SERVICE BULLETIN #0002 (rev. 2)

RELEASE DATE: 11/02/2021
EFFECTIVE DATE: 11/02/2021
SUBJECT: Reinforcement of the upper join between the centre and rear fuselages
MODELS AFFECTED: rev. 1 – Sling 4 and Sling 4 TSi (*all from SN#001 to SN#060*)
rev. 2 – Sling 4 and Sling 4 TSi (*all from SN#001 to SN#060 and non-parachute versions from SN#060 to #306*)
COMPLIANCE TIME: At the next MPI (*Mandatory Periodic Inspection*)
LABOUR TIME: Inspection only: 0.25 hours
Inspection & Repair: 2 hours

To strengthen and prevent fatigue related failures to the upper centre and rear fuselage connection points.

5.2. Procedure:

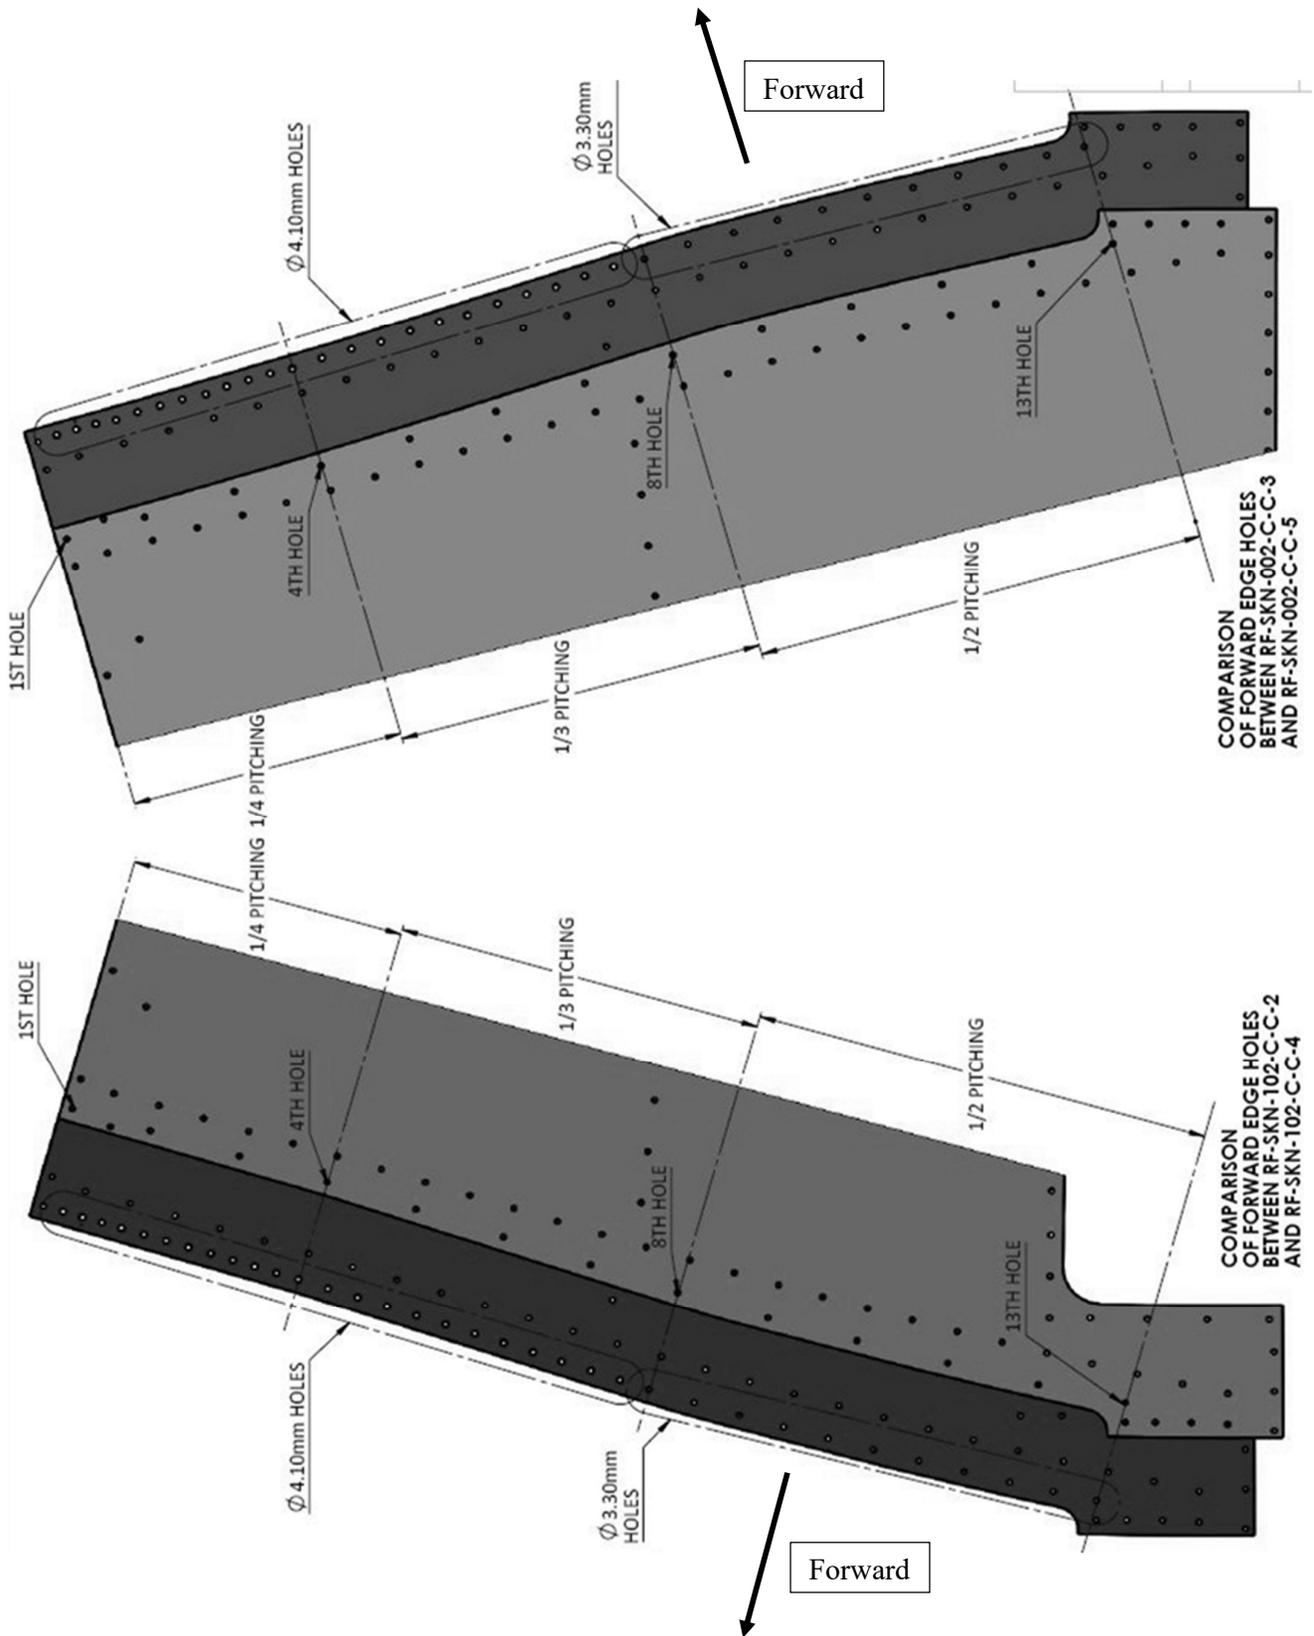
4. Use a pen / pencil to draw a straight line on the curved skin surface of the upper rear fuselage skin, that passes through the existing rivet line connecting the skin to the rear, upper lip of the composite canopy frame. Ensure that the curve is the same distance from the edge of the skin along its entire length.

5. Use a ruler and a pen / pencil to mark-off the points along the curve where the new rivets will be inserted. 1/4 pitching (from the original rivet spacing) is required for the first set of holes, 1/3 pitching is required for the second set and 1/2 pitching is required for the last set of holes, from the top of the aircraft downwards. *Note – for parachute versions, the first holes will be covered by the parachute blowout skin and it is not required to remove this skin. Simply adjust the pitching in a practical fashion for the spacing of the first hole as close as possible to the parachute blowout skin edge.*

6. Use a 4.0mm (5/32") diameter drill bit to drill the holes marked as 4.10mm holes on the technical drawing and a 3.2mm (1/8") diameter drill bit to drill the holes marked as 3.30mm holes. Ensure to drill the holes in such a manner such that a correctly sized rivet flange will lie flush with the aluminum skin when fastened.

7. Pull the 3.2 x 8mm (1/8" x 5/16") and 4.0 x 10mm (5/32" x 3/8") multi-grip rivets with the pneumatic or hand operated pull riveter, whilst ensuring that the rivet flange lies flush with the aluminum skin.
8. Once the new rivets have been added, certain of the original 3.2mm rivets should be replaced with 4.0mm rivets. The regions with 1/3 and 1/4 pitching must contain 4.0mm rivets, and the quantity depend on if the aircraft is a parachute or non-parachute version. Please see attached drawings.
9. Remove the original, 3.2mm rivets, with a 4.0mm drill bit and continue to open the hole.
10. Fit and pull the remaining 4.0 x 10mm (5/32" x 3/8") multi-grip rivets with the pneumatic or hand operated pull riveter while ensuring that the rivet flange lies flush against the skin.
11. Touch-up the work completed with appropriate touch-up paint

6.1. PARACHUTE VERSION

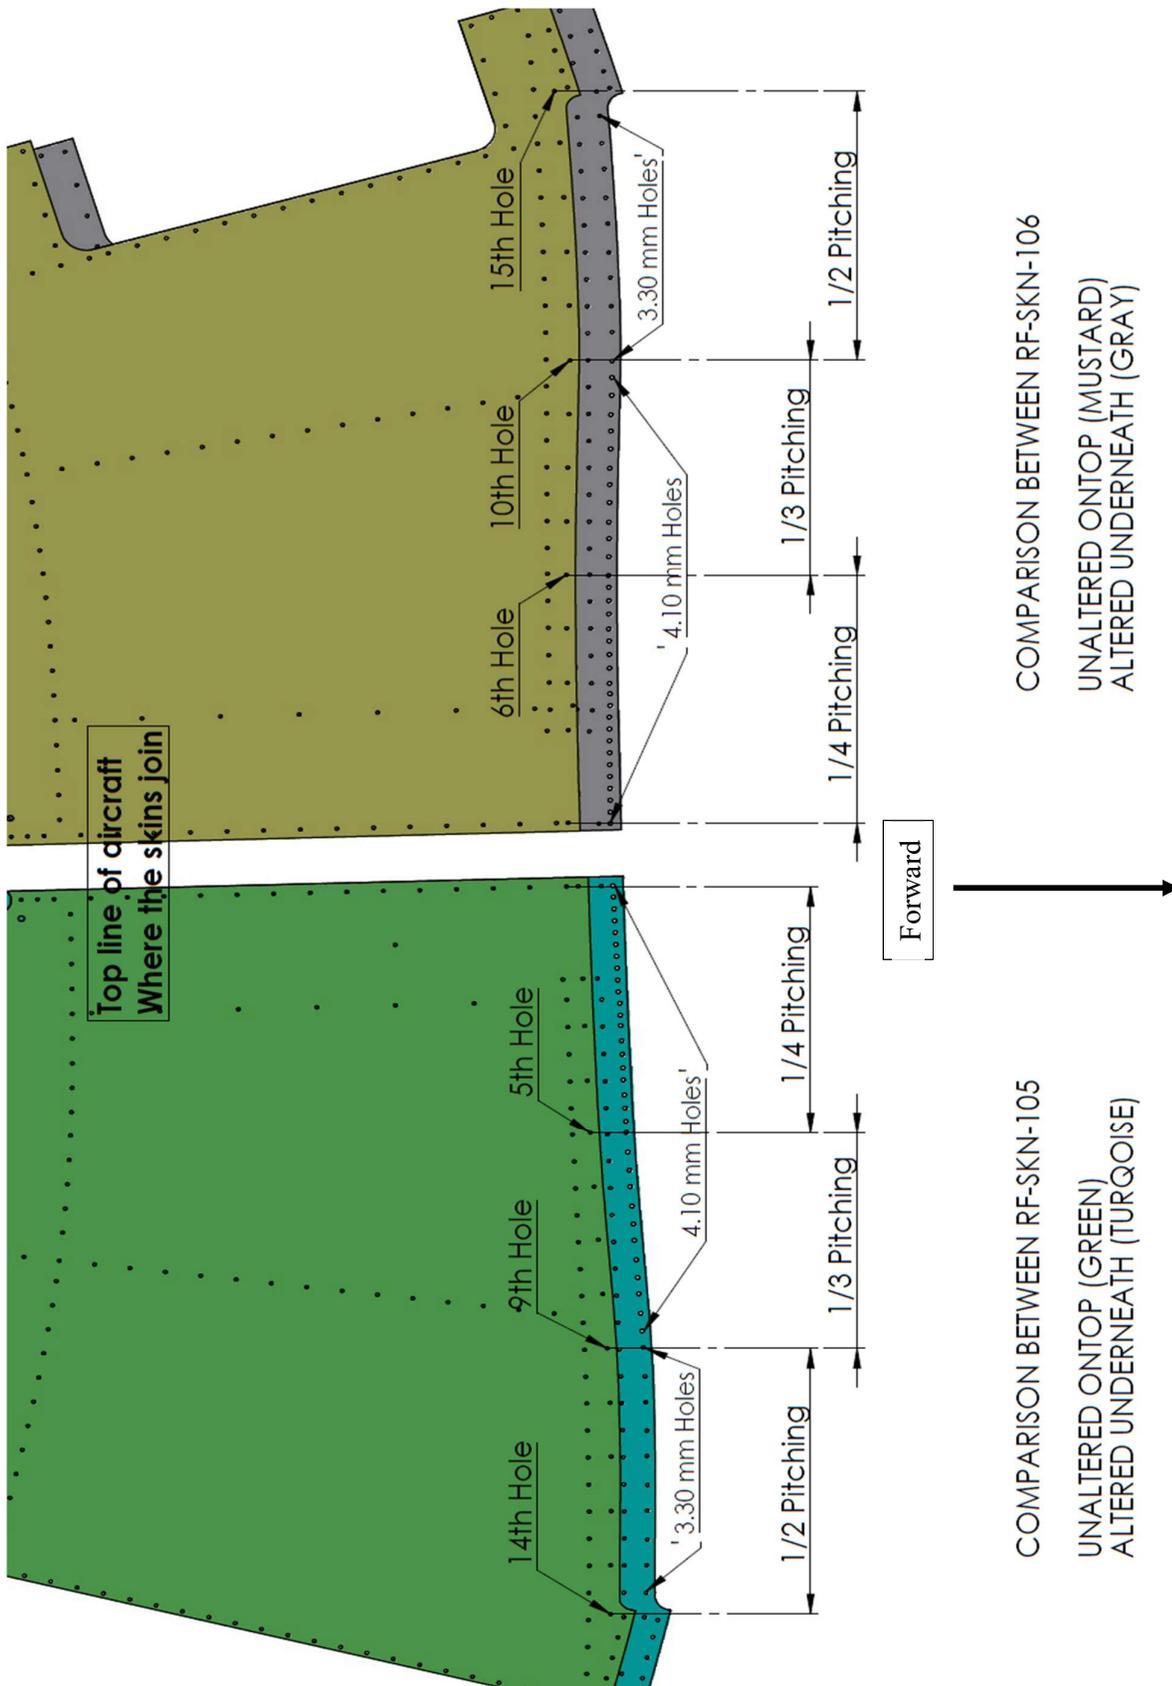
1. Read and understand the inspection, procedure instructions and attached drawings in their entirety before attempting any work.
 - a. The instructions provide for fitting a number of additional rivets to the two upper fuselage skins, and the replacement of certain additional rivets.
2. The affected skins on the upper rear fuselage have the part numbers:
 - a. Parachute Versions
 - i. RF-SKN-102-C-C-2 (*Left*) (*or earlier*)
 - ii. RF-SKN-002-C-C-3 (*Right*) (*or earlier*)
 - b. Non-Parachute Versions
 - i. RF-SKN-105-C-C-2 (*Left*) (*or earlier*)
 - ii. RF-SKN-106-C-C-2 (*Right*) (*or earlier*)

FIGURE 3 | ALTERNATIVE SPACING

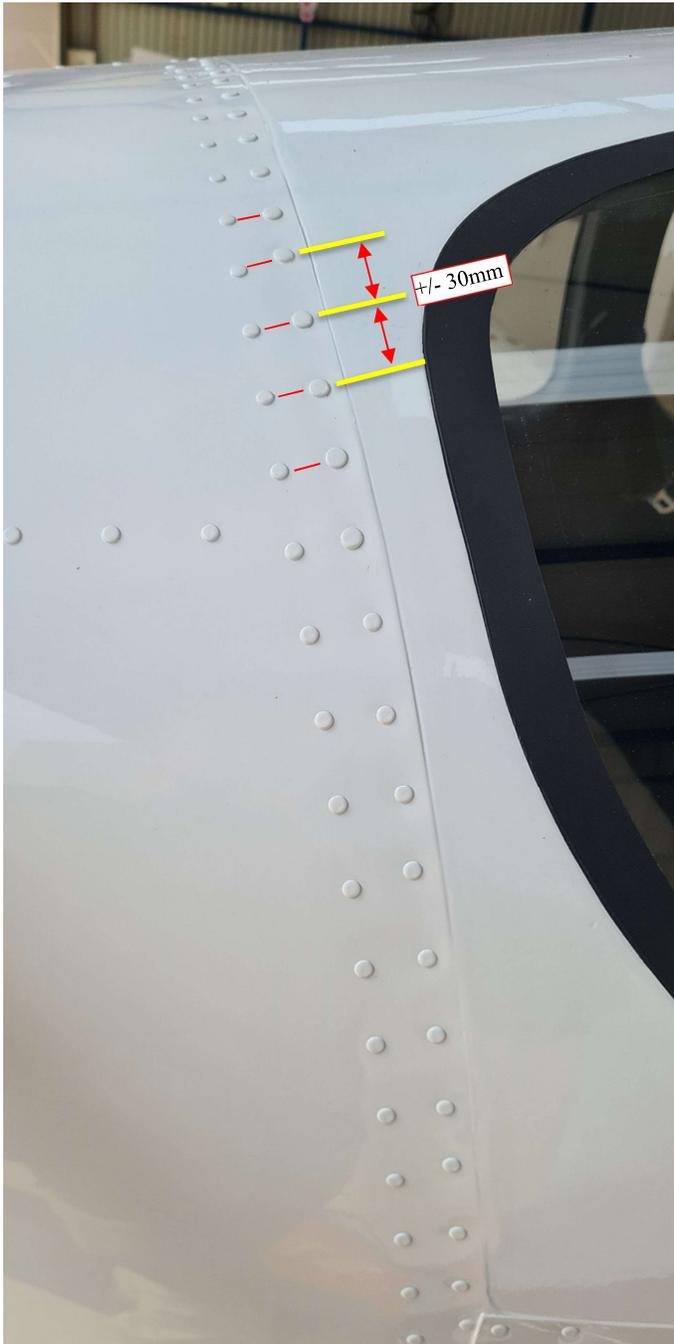
If the spacing of the rivets differs from the diagrams provided above, but has the same as seen in Figure 3 (left), then an alternative spacing is required. The red markup in the figure is to show that the forward and aft rivets are inline.

If moving from bottom to top, the pitching does not change from 1/2 to 1/3 (original pitching) as in the technical drawings in section 6. This is still a sufficient number of rivets in this section and are required to remain. If the rivets in this section are 3.3mm, then they are required to be drilled out and replaced with 4.0mm rivets, as described in point 8. in INSTRUCTIONS.

This requirement, in this appendix, is due to the original holes being misplaced in the 1/3 section, and if the diagrams/above instructions were to be obeyed, there will be an additional hole/rivet every 3rd rivet.

The additional rivets may be added in the 1/4 pitching section, as per diagrams in section 6.
